FINAL MITIGATION PLAN ADDENDUM

WYANT LANDS MITIGATION SITE PHASE II – PROJECT EXPANSION

RE: Wyant Lands Phase II Project Expansion
Lincoln County, NC
Response to NCIRT Review Comments
USACE Action ID No: SAW-2021-02449
NCDMS Project No: 100595

RE: Wyant Lands Mitigation Site Addendum
Lincoln County, NC
Catawba River Basin 03050102
Response to NCDMS Addendum Comments

Figure 2A Addendum Site Map
 Wyant Lands Mitigation Site
 Catawba River Basin 03050102
 (03050103 Expanded Service Area)
 Lincoln County, NC

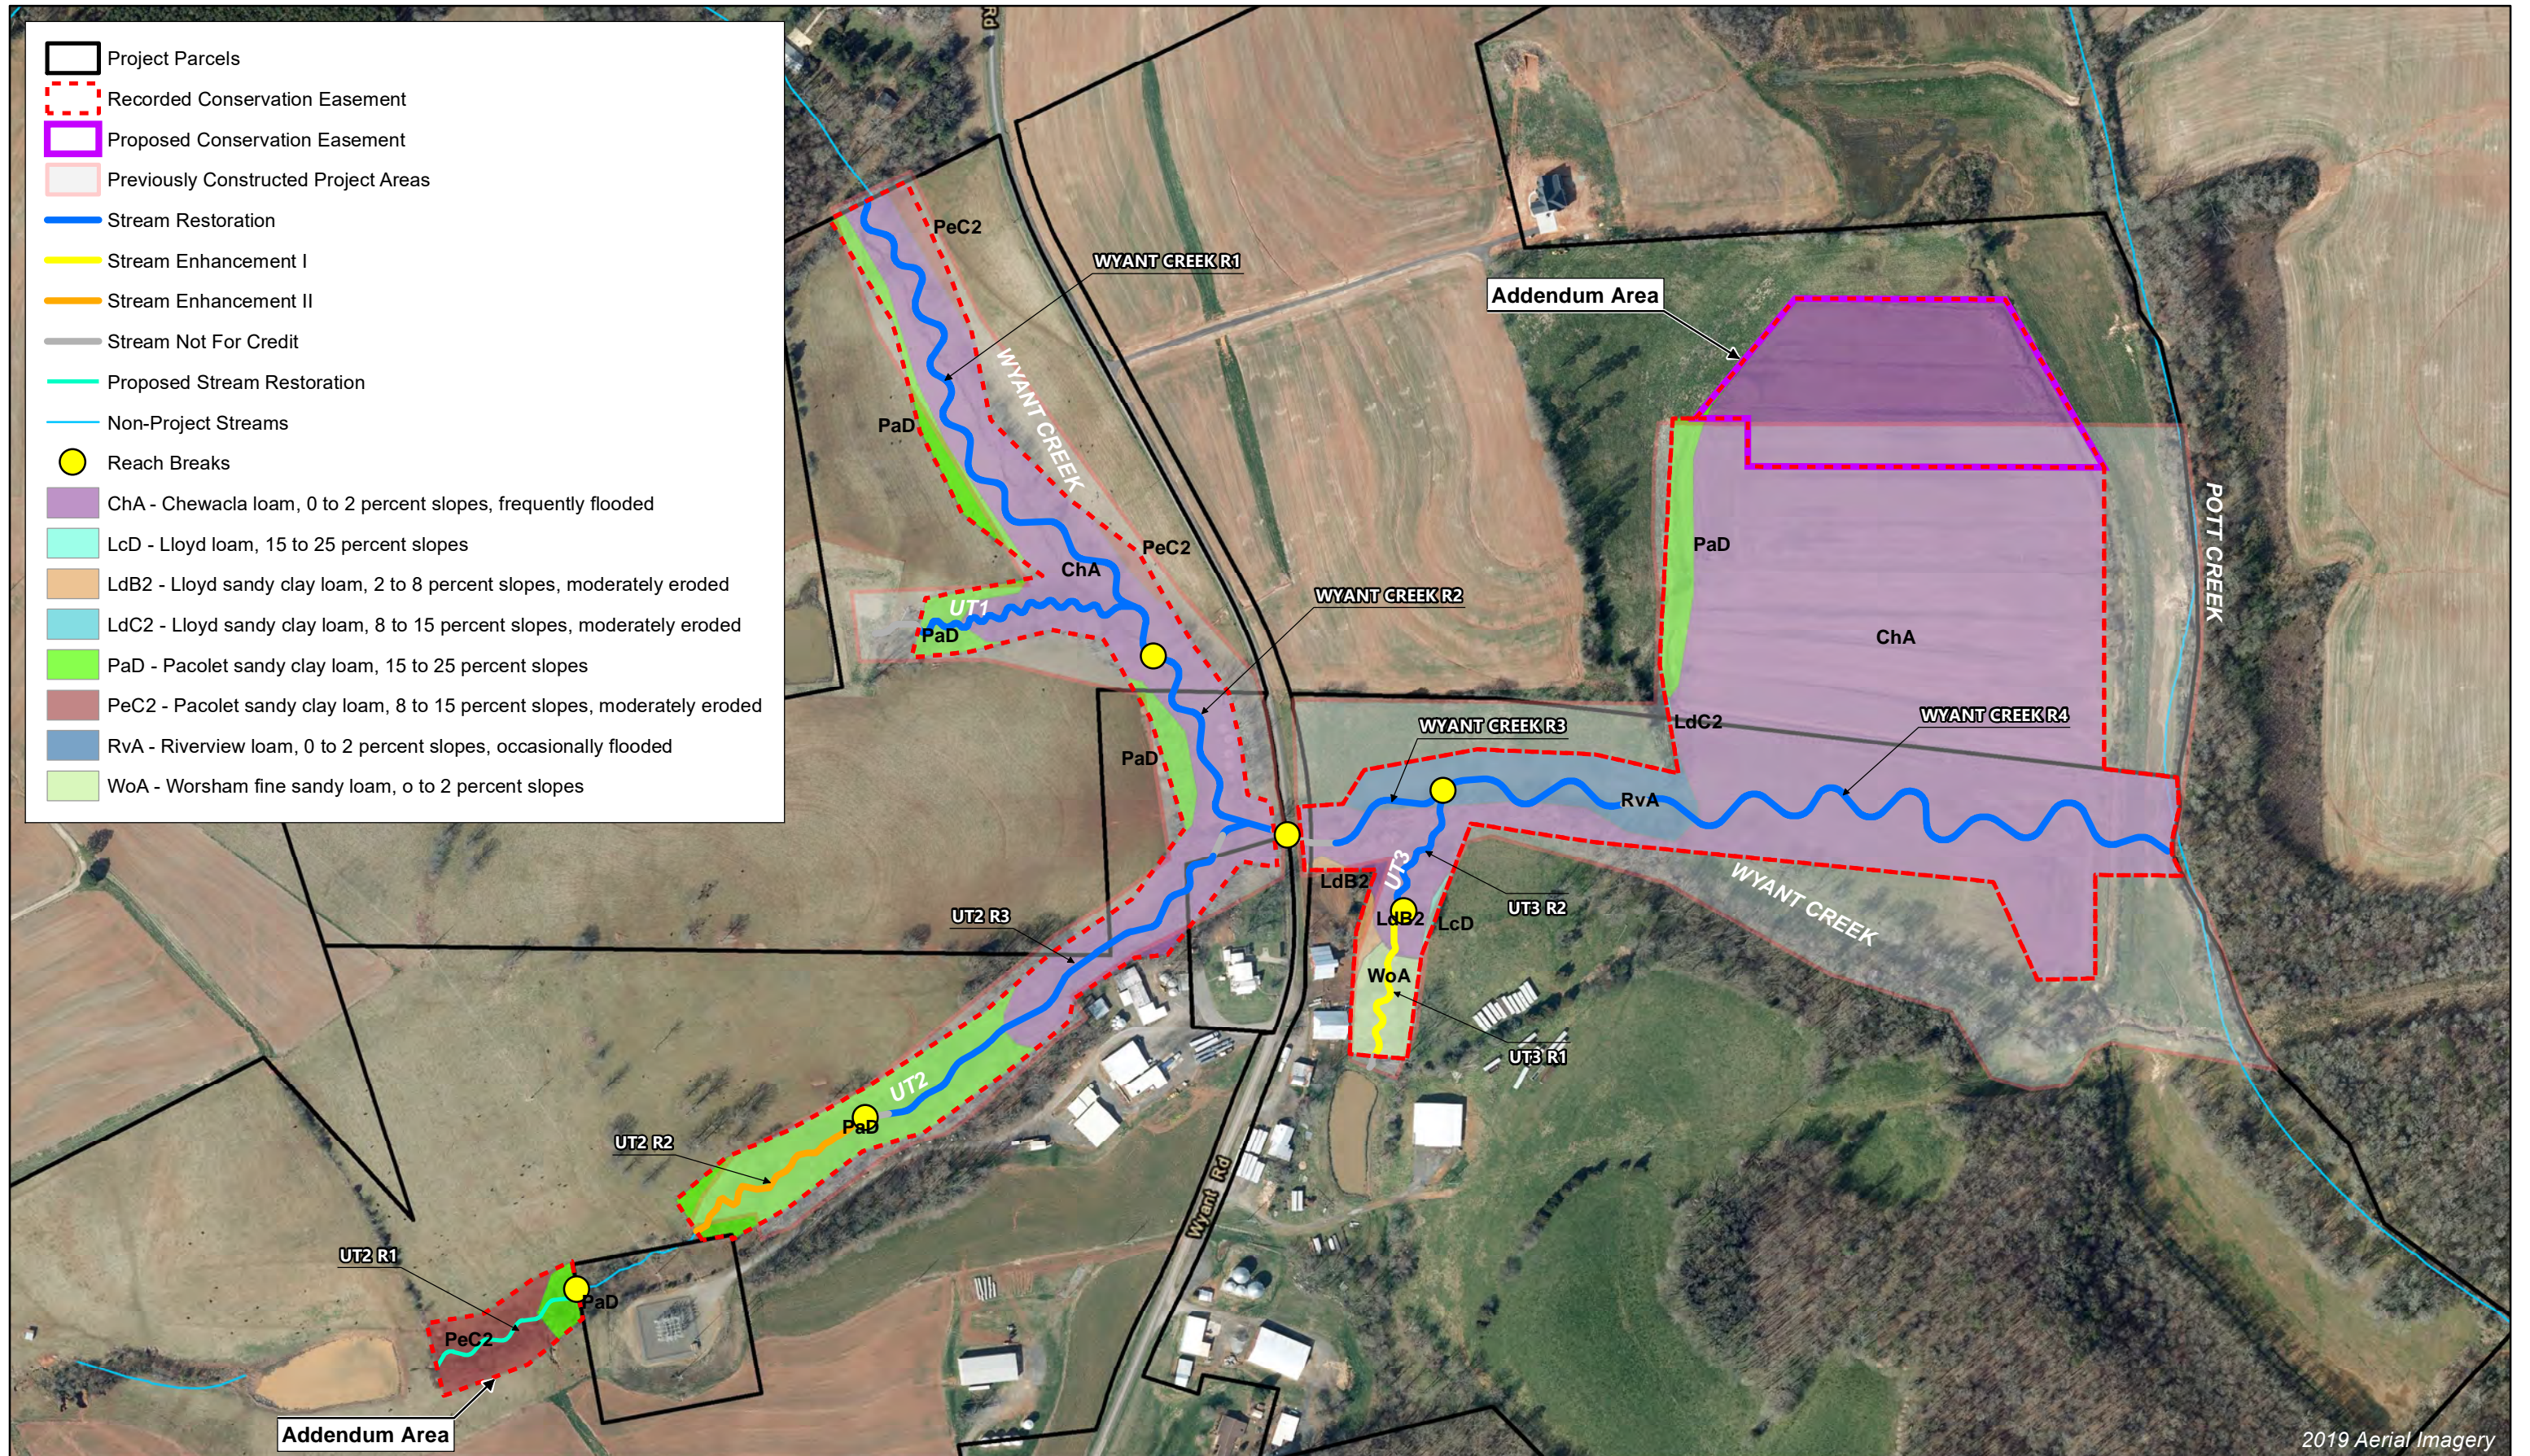
5. *Figure 2A: It appears that not all of the existing wetland T will be captured in the addendum area (to the north). Will this pose a problem for the landowner if the field adjacent to the conservation easement becomes too wet?*

Wildlands Response: The area of existing Wetland T that is outside the proposed addendum area will be raised in elevation (1 foot max) but is anticipated to remain wet after the project. This area of property is currently wet and the landowner understands it will remain wet post construction. Grades increase quickly as you move north of wetland T towards the property line and spoil material removed from the proposed wetland area will be used to increase elevations in the 100-foot gap between the addendum easement and the property line to ensure an adequate travel path for the landowner. Impacts to Wetland T are listed as temporary within the 401/404 permit submittal for the project.

Wildlands Response: Existing site ditches and ditches to be filled were added to Figures 2A and 6.1A, respectively. All ditches in or near the proposed project boundary are going to be filled and plugged. No ditches that will influence site conditions exist adjacent to the addendum conservation easement.

Wyant Lands Mitigation Site Addendum
Lincoln, North Carolina
Wetland Grading Overview

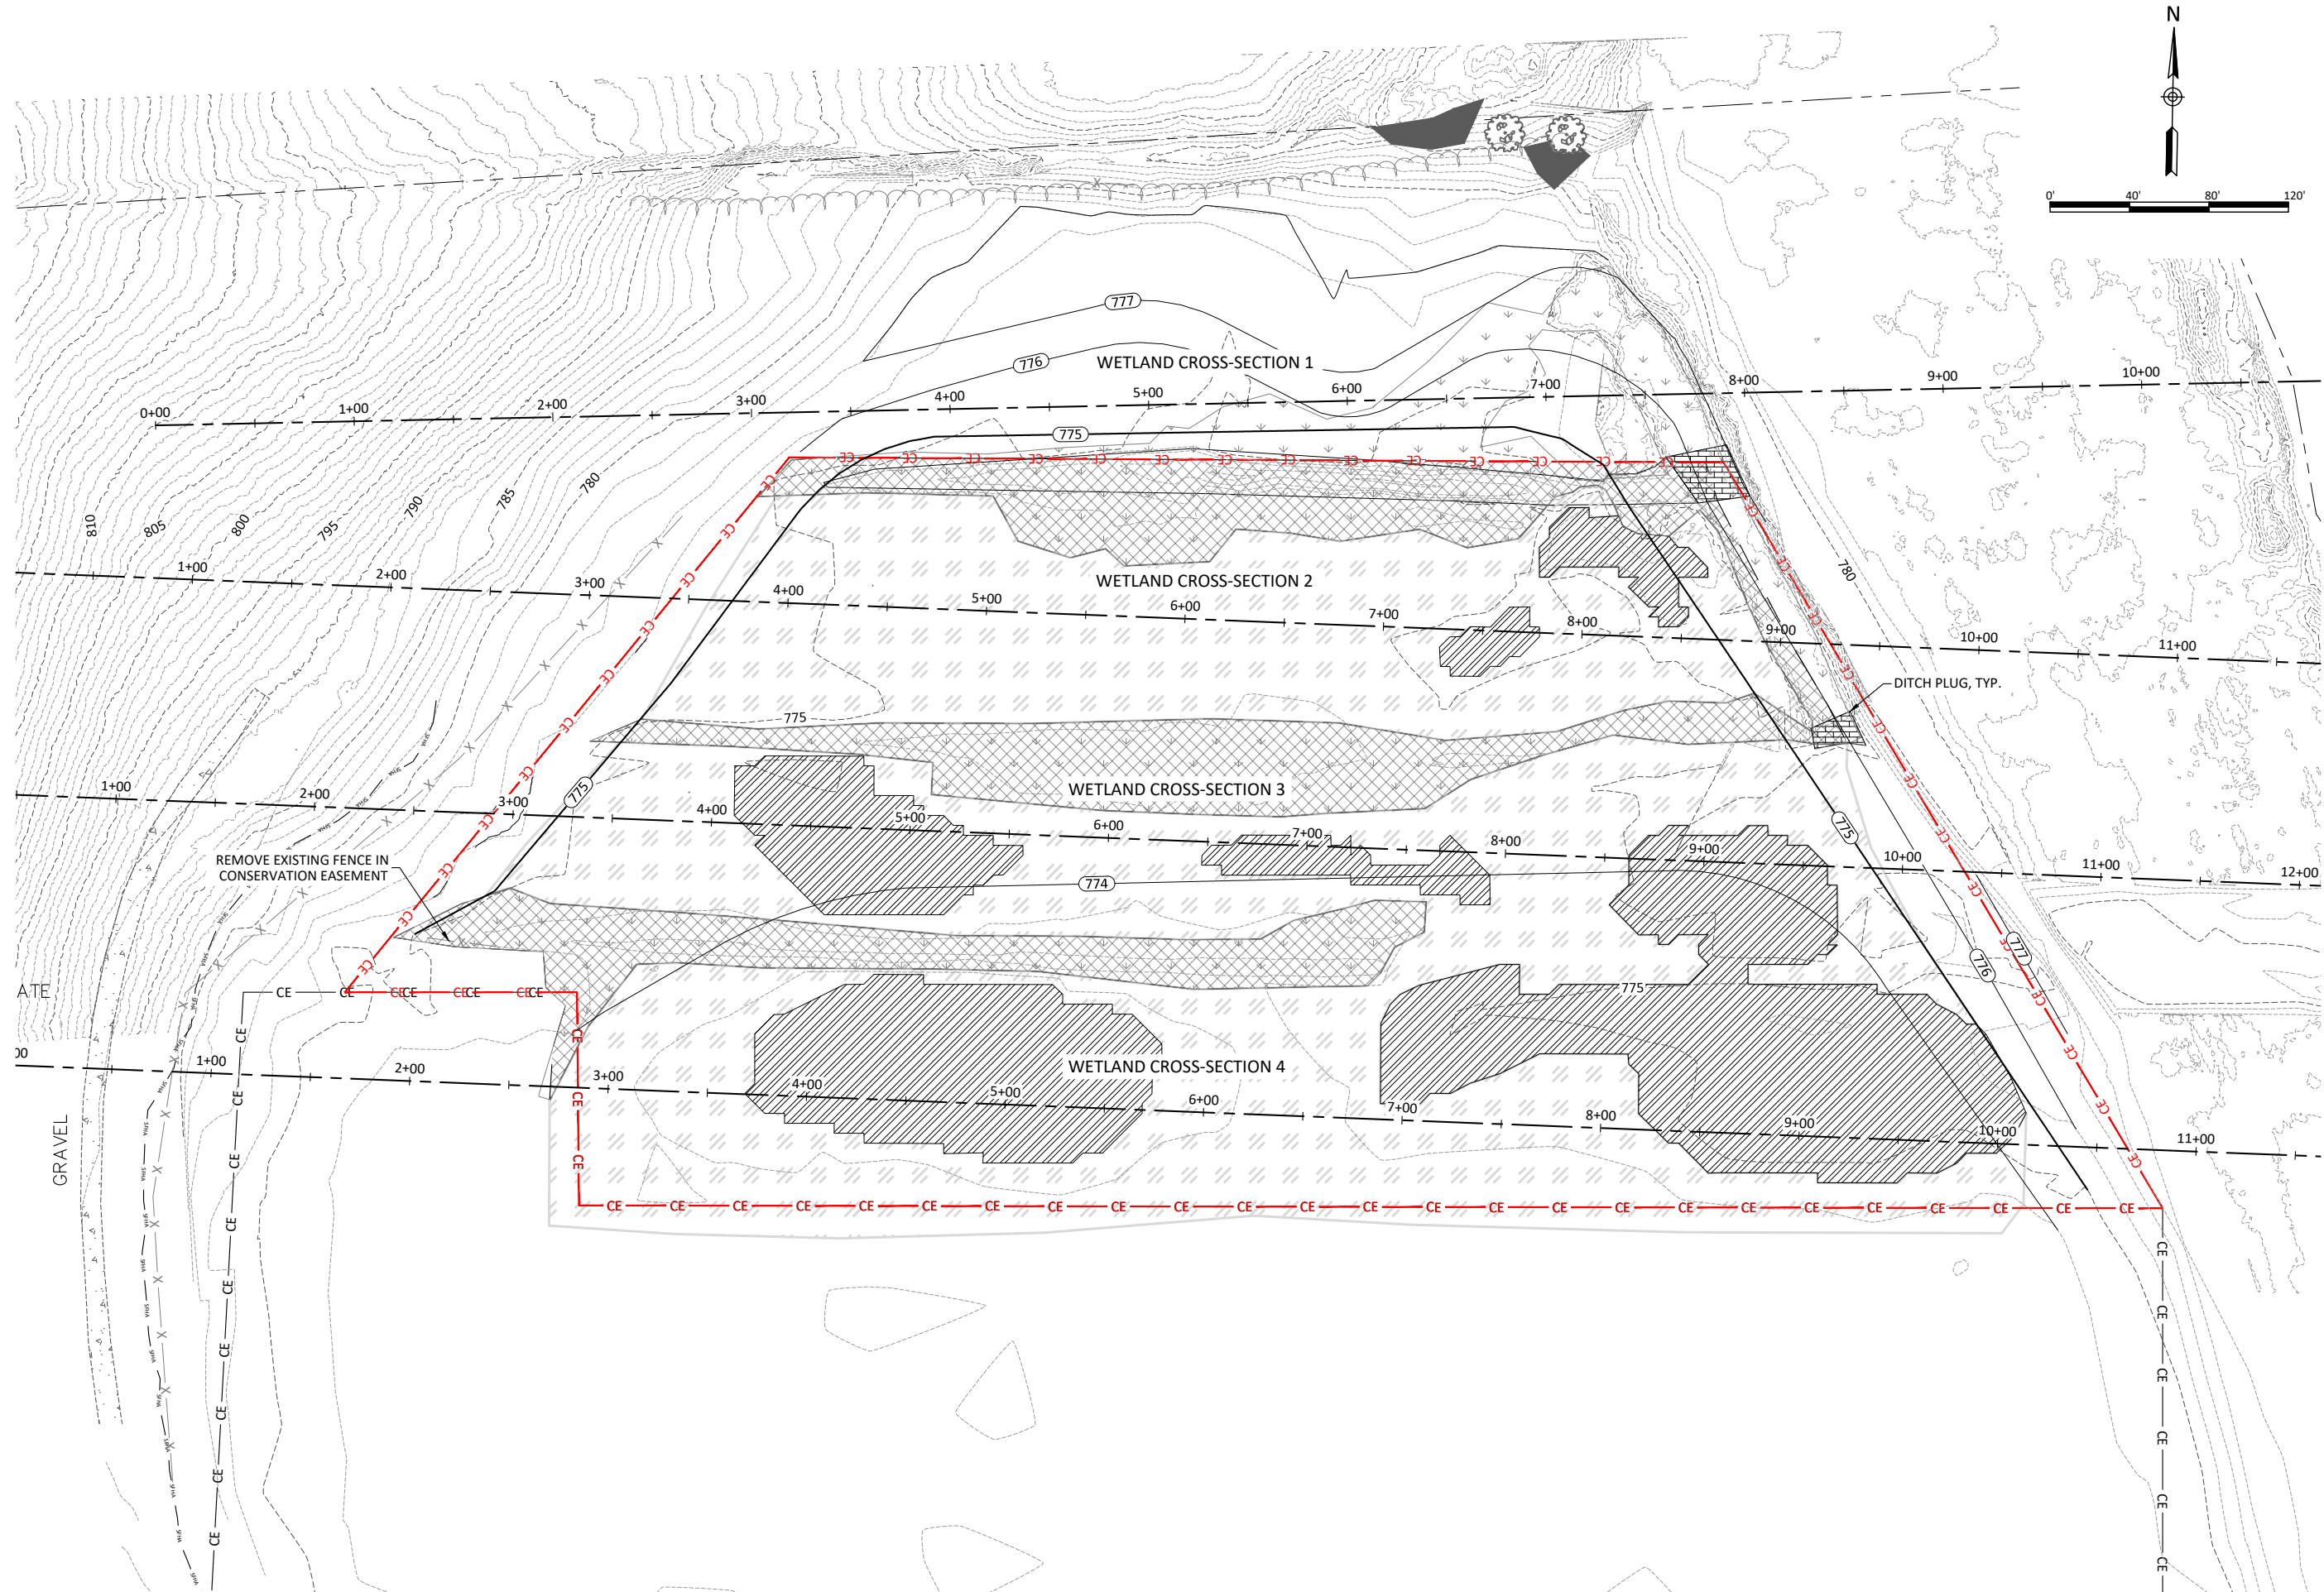
6. *Sheet 2.0 – With the grading proposed outside the easement, is it expected to result in a loss of any open water and/or wetland areas? It appears the Open Water 2 area will be graded up to elev. 777. Also, what is the minimum ditch plug length being proposed.*

Wildlands Response: Open Water 2 will be permanently impacted and filled. Within the conservation easement, this area will be restored to bottomland forested wetland. See response to comment #5 from Kim Browning above regarding Wetland T. The 401/404 permit submitted for project includes these areas of impact. Minimum ditch plug length is 8 feet, but it should be noted that all ditches are proposed to be filled for their entirety in addition to proposed ditch plugs.
